NU-03-0180

January 30, 2004

RE: Doris North Pre-Hearing Conformity Analysis and Adequacy Review, Miramar Hope Bay Ltd. Final EIS

Figure 4 – Cross-Section and Water Surface Elevation at Doris Lake outlet gauging station, looking downstream. Upper banklines are approximate; lower cross-section and benchmark elevation were measured.

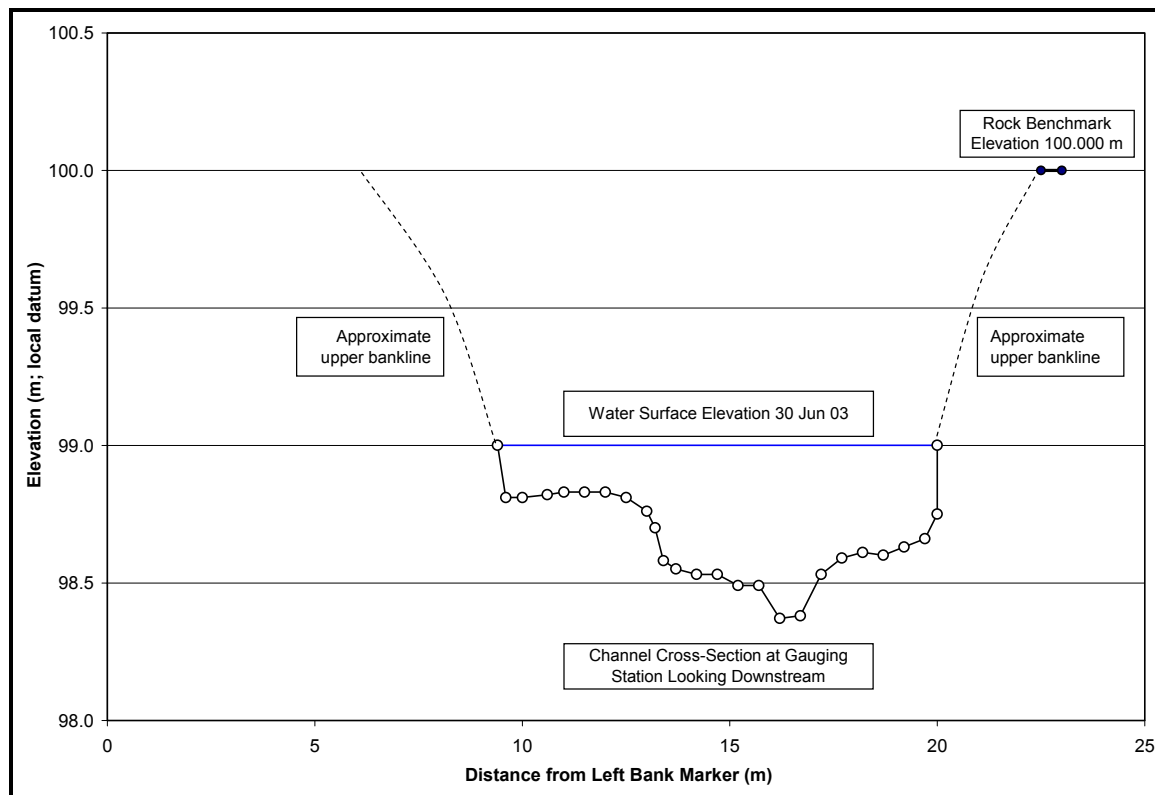
- *Site photos of the crossing location showing the river banks.*
- *Technical design of the proposed clear-span bridge including, but not limited to, the following:*
 - *exact dimensions of the bridge structure;*
 - *dimensions of the Doris Lake outflow - water depth, river width, high water mark, etc.;*
 - *bank full distances;*
 - *distance from the bank full location to the toe of the slope of the embankment supporting the clear span bridge.*

Complete details of the preliminary bridge design have been presented in Figure 5.8 SD A4. The bridge deck will be a minimum distance of 2.5m above the stream centerline, and the toes of the bridge abutments will be a minimum distance of 10m apart. The average stream width used for design purposes is 4m, which allows a minimum distance of 3m on either side. The exact dimensions of the bridge structure and abutments will be confirmed during the detailed design stage. Exact dimensions of the Doris Lake outflow water depth, river width, high water mark etc. have not been measured; however these will be confirmed prior to proceeding with the detailed design.

Figures 1 to 3 are photographs (below) of Doris Outflow taken during the field visit between 30 June and 1 July 2003 and provide an overview of the morphology of the outlet channel. Figure 1 shows the crossing location including the river banks. A stream discharge measurement was also undertaken on 30 June and a channel cross-section (below the water surface elevation) is provided in Figure 4.

- **Water depth:** During discharge transect measurements in August and September 2003, the maximum recorded depth was 0.38 m, with a mean depth of 0.26 m.
- **River width** in June was approximately 12 m. During discharge transects in August and September 2003, river width ranged from 2.8 to 4.7 m.
- The **high water mark** during the June site visit was approximately 1 m above existing conditions.
- The **bank full distance** during the June site visit approximately 14 m across the river channel.
- Distance from the bank full location to the toe of the slope of the embankment supporting the clean span bridge.
